UNITED STATES PATENT AND TRADEMARK OFFICE

APPLICATION NO.	FILING DATE	FIRST NAMED INVENTOR	ATTORNEY DOCKET NO.	CONFIRMATION NO.
10/739,206	12/19/2003	Sharon D. Patrick	DET1927	9873

This is the second non-final Office Action for application number 10/739,206 Tissue Paper Supporting Assembly, filed on 12/19/03. Claims 1-12, 15-21 are pending. This is the second non-final Action is in response to applicant's reply dated 9/8/04. The text of those sections of Title 35, U.S. Code not included in this action can be found in a prior Office action.

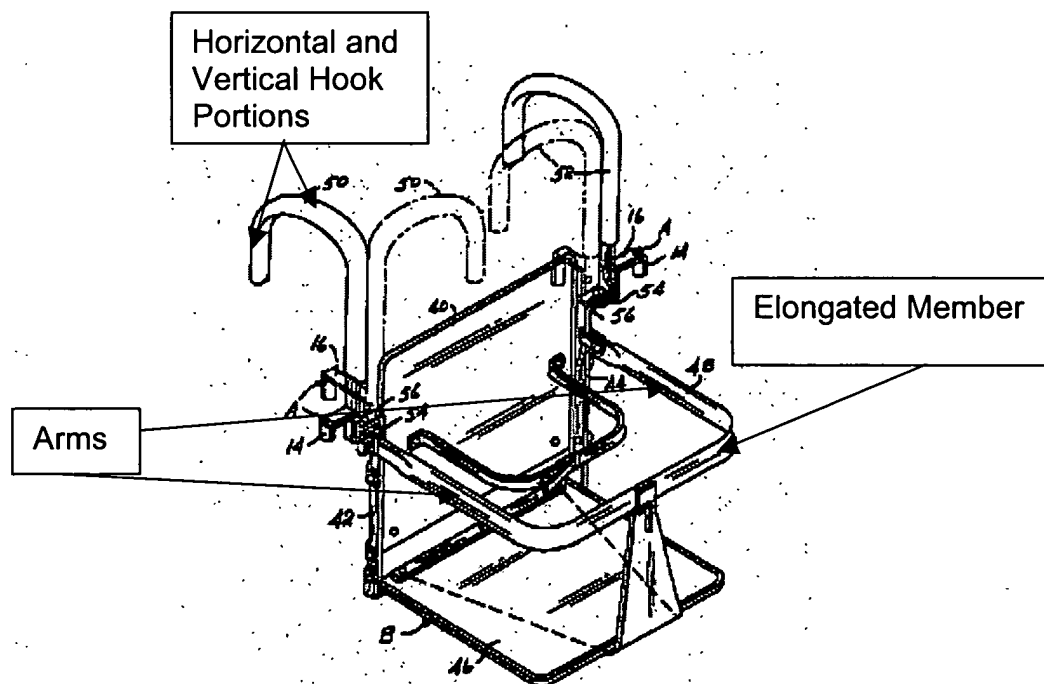
Berlin discloses the basic inventive concept including wherein the bracket (48) has an elongated member (See drawing Below) which is substantially the same length

as the length of the panel, the bracket having a pair of arms (See Drawing) attached to and extending away from opposite ends of the elongated member, the arms being orientated perpendicular to the elongated member, each of the arms having a free end with respect to the elongated member, each of the free ends being attached to one of an outer edge of the legs. Berlin also discloses that the coupler (50, 52) includes a pair of hooks attached to the legs and extending in an opposite direction than the bracket (48), the hooks having a horizontal portion and a downwardly extending vertical portion spaced from the legs.
